ITEM: 6.1	REPORT SUMMARY MINOR VARIANCE APPLICATION FILE NUMBER A003/24
------------------	--

MINOR VARIANCE APPLICATION FILE NUMBER A003/24

CITY WARD #:	2
APPLICANT:	Maria Barbieri and Sandra Santos
AGENT:	2730099 Ontario Corporation
PROPERTY:	43 Roxana Avenue, Woodbridge
ZONING DESIGNATION:	See below.
VAUGHAN OFFICIAL PLAN (2010) DESIGNATION:	Vaughan Official Plan 2010 ('VOP 2010'): "Low-Rise Residential".
RELATED DEVELOPMENT APPLICATIONS:	None
PURPOSE OF APPLICATION:	Relief from the Zoning By-law is being requested to permit two existing sheds (located in the westerly side yard and rear yard), a swimming pool, a constructed addition located in the easterly side yard, increased maximum driveway width and reduced soft landscaping requirements in the rear yard.

SITE PLAN

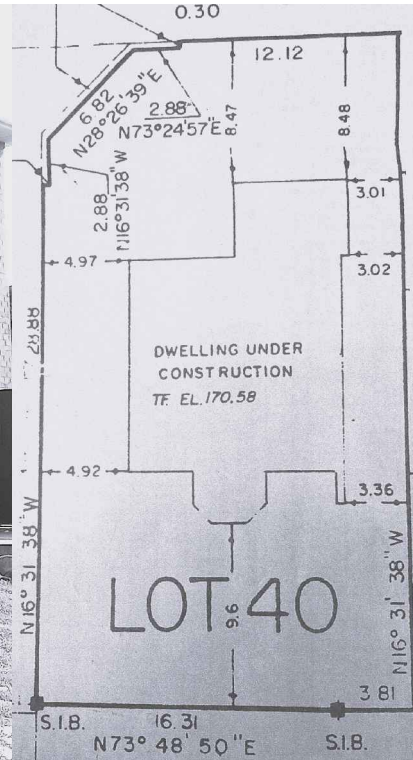
The Owner / Applicant has revised their Site Plan to remove and relocate the existing carport wall. Initially set at a 0m setback from the east property line, the wall will now be moved to maintain a 0.6m setback, in accordance with the Engineering Design standards of the City of Vaughan and Zoning By-law 001-2021. While it is preferred to move the entire carport wall by 600mm, the Owner / Applicant proposes to shift the front portion of the wall by 0.3m and the remaining rear portion by 0.6m. The proposed work by the Owner / Applicant is increasing the lot coverage on the subject property by 30%. The added hardscape may have impacts on the City's Storm Water management system. Development Engineering strongly encourages the Owner / Applicant introduce Low-Impact Development (LID) measures (e.g., bioswales, permeable pavers, rain gardens, rain barrels etc.) to reduce the impacts to the stormwater system. Should further information be required, please contact the Development Engineering COA reviewer. Due to the size of the existing structures including two sheds, carport and greenhouse on the subject property, which totals to 63.48 m², the Owner/Applicant must acquire a Lot Grading Permit from the Development Inspection and Lot Grading Division of the City's Development Engineering Department. It's important note that any in-ground structure exceeding 10 m² necessitates a Grading Permit. Once the Grading Permit is obtained, please reach out to the Development Engineering Reviewer to clear the Condition imposed on this application. The Owner / Applicant shall apply for a Pool Grading Permit with the Development Engineering (DE) Department. Please visit the grading permits page at City of Vaughan website to learn how to apply for the Pool Permit. If you have any question about Pool Grading Permit, please contact the Development Engineering Department through email at DEPermits@vaughan.ca. The Development Engineering Department does not object to the Minor Variance application A003/24, subject to the following condition(s):

The Development Planning Department has no objections for the proposed reduction in soft landscaping in the rear yard (Variance 3). Approximately 70.27 m² of soft landscaping in the form of river rock is proposed around the perimeter of the rear yard that will allow for stormwater to infiltrate and provide a distinct break from the existing hardscape in the rear yard. DE Staff have also reviewed the application and do not have any concerns regarding drainage in the rear yard.

The Development Planning Department has no objection to Variance 5 to permit the existing in-ground pool located in the south-west portion of what functions as the greater rear yard, closer to the exterior lot line than the principal dwelling. The majority of the existing pool is located behind the west wall of the dwelling and does not adversely impact the visual prominence of the dwelling. The existing in-ground pool also complies with the minimum exterior side yard and rear yard setback requirements of Zoning By-law 001-2021.

The Development Planning Department has no objection to Variance 6 to permit a maximum driveway width of 9.16 m. The 0.16 m increase is negligible from a visual perspective and the existing landscaped areas in the front yard exceed the requirements of Zoning By-law 001-2021.

Development Engineering Recommended Conditions of Approval:	The Owner / Applicant shall provide a Letter of Undertaking, using the City's template, confirming that the carport wall has been moved away from the property line as agreed upon. This adjustment must be in accordance with the submitted Site Plan Drawing (A00, revision 14, dated May 21, 2024) to the satisfaction of the Development Engineering Department. Please reach out to the DE Reviewer at rex.bondad@vaughan.ca for a copy of the Letter of Undertaking. The Owner / Applicant shall submit an application and obtain an approved Grading Permit before initiating any work on the property. The Final Lot Grading and/or Servicing Plan will be required for the Grading Permit Application. Please visit the Permits page of the City of Vaughan's website: Permits City of Vaughan to apply for a Grading Permit. For any inquiries regarding the Grading Permit, please email DEPermits@vaughan.ca

EX. SHE #2 PLAN
SCALE 3/16" = 1'-0"

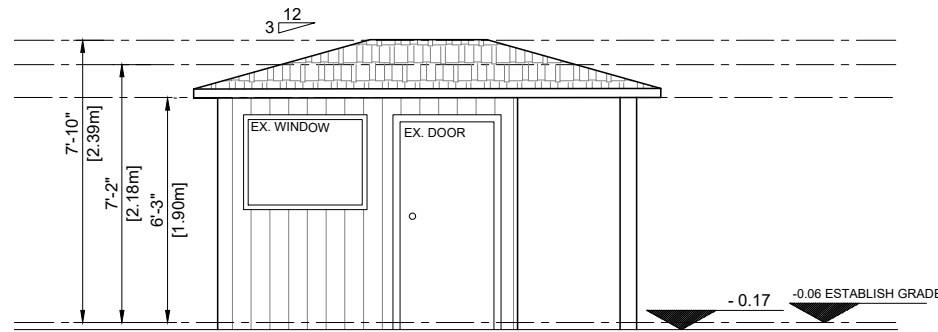
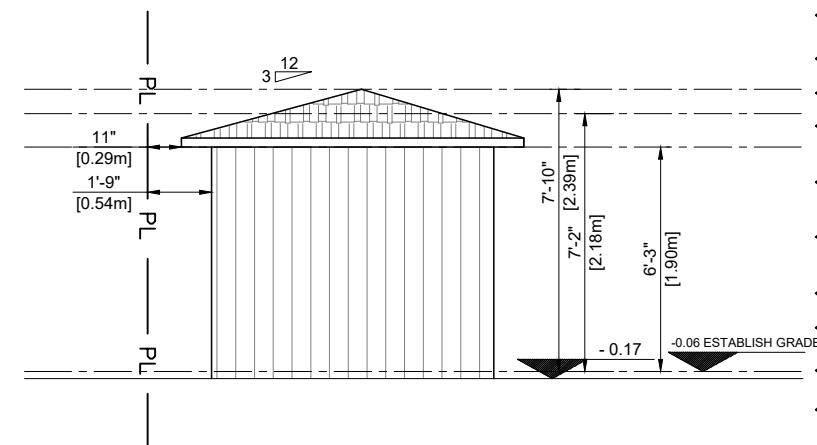
The Development Planning Department has no objection to Variances 1, 2, & 4 to permit the existing accessory structure (Shed #2). Shed #2 is located within the fenced-off area portion of the exterior side yard. The shed complies with the maximum height and lot coverage requirements for accessory structures in Zoning By-law 001-2021. The proposed minimum setbacks from the exterior side lot line are not anticipated to pose significant adverse impacts to the abutting street (Northlane Road) as the eaves and gutters do not overhang outside of the property line, and sufficient space for maintenance and safe access is provided. Additionally, sufficient spatial separation is provided between it and the dwelling to maintain its appearance as a separate and distinct building from the dwelling. The Development Engineering ('DE') Department have also reviewed the proposal and are satisfied that drainage will be maintained. As such, staff are of the opinion that Shed #2 will have minor massing and visual (privacy) impacts on the existing streetscapes of Northlane Road and Roxana Avenue.

GREEN HOUSE AND SHED #1 ROOF PLAN
SCALE 3/16" = 1'-0"

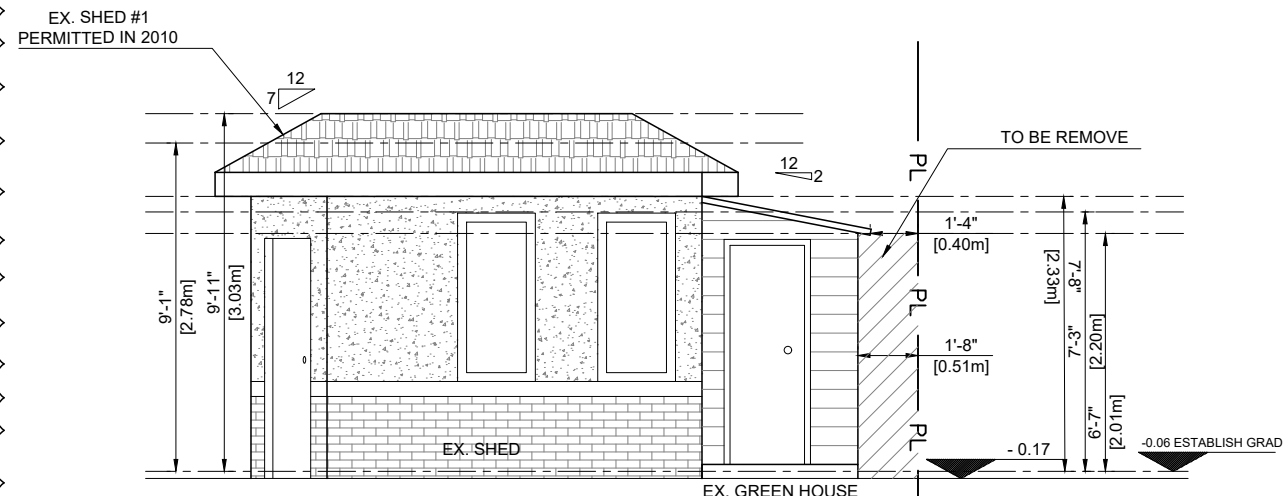
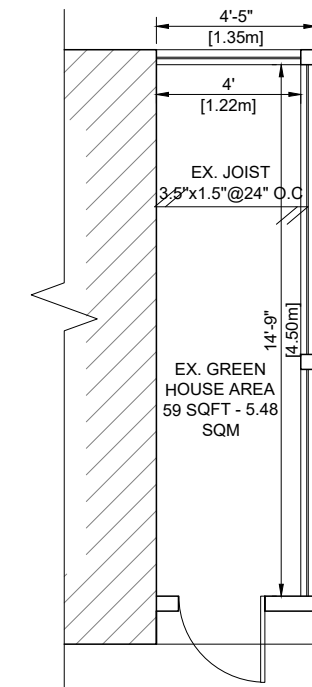
The Development Planning Department has no objection to Variances 7 and 8 to permit the attached sunroom at the rear of Shed #1. The shed is located in the southeast corner of the rear yard and was previously approved through Minor Variance Application A090/10 with a minimum rear yard setback of 1.5 m and a minimum interior side yard setback of 0.6 m. The attached sunroom to the accessory shed exceeds the approved minimum interior side yard setback (as approved through File A090/10) and encroaches into the minimum required rear yard (by 0.99 m). The sunroom addition presents with minimal mass and is within the height and coverage requirements of Zoning By-law 001-2021. The 0.51 metre setback provides sufficient space for safe maintenance and access. The greenhouse wall facing the rear lot line is modest in height, its roof has a modest slope, and there is no eave overhang onto the neighbouring properties. Anticipated massing impacts resulting from the east wall's proximity to the interior side lot line is partially mitigated by the existing tall wooden privacy fence. In addition, the abutting property to the rear (48 Northlane Road) has an accessory building facing Shed #1, which assists in alleviating any perceived massing impacts on the abutting property.

EX. ADDITION PLAN

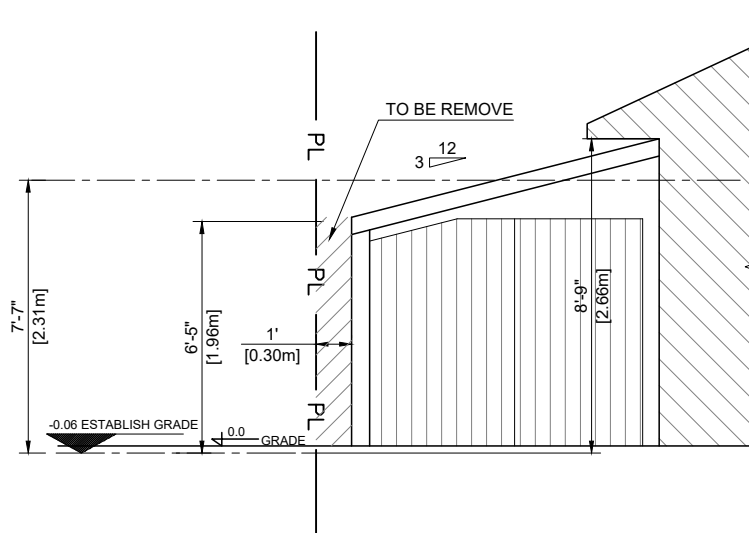
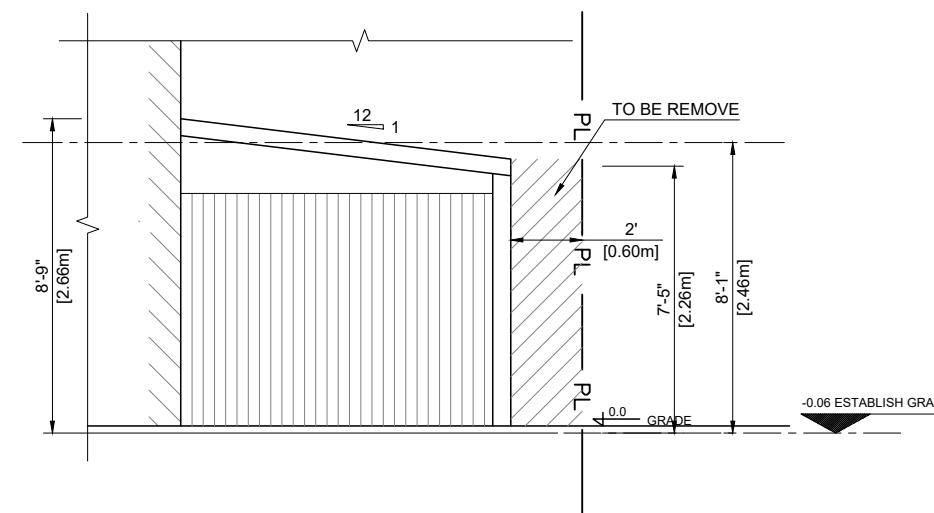
Development Planning Staff have no objection to Variance 9 to permit a reduced interior side yard setback for the existing addition to the dwelling (carport). The carport is used to house a vehicle and is set back from the front wall of the dwelling that alleviates any perceived massing or use impacts on the existing streetscape. At the request of the Development Planning Department, the Owner has proposed to increase the interior side yard setback to 0.6 m along approximately half of its total length. The requested 0.3 m encroachment into the required interior side yard is requested only at the front of the carport to allow for the maneuvering of a vehicle around the existing bump-out on the east wall of the primary dwelling. The rear half of the carport maintains a 0.6 m setback and complies with the requirements of Zoning By-law 001-2021. The carport also complies with the maximum building height and lot coverage requirements of Zoning By-law 001-2021. The carport is a single storey structure of modest height, with a more modest wall height facing the abutting neighbouring property to the east (39 Roxanna Avenue) due to the slope of its roof. As such, the carport provides sufficient space for safe access and maintenance and is not anticipated to have adverse use (privacy) or massing impacts on the neighbouring property to the east (39 Roxana Avenue), or the existing streetscape and surrounding neighbourhood.
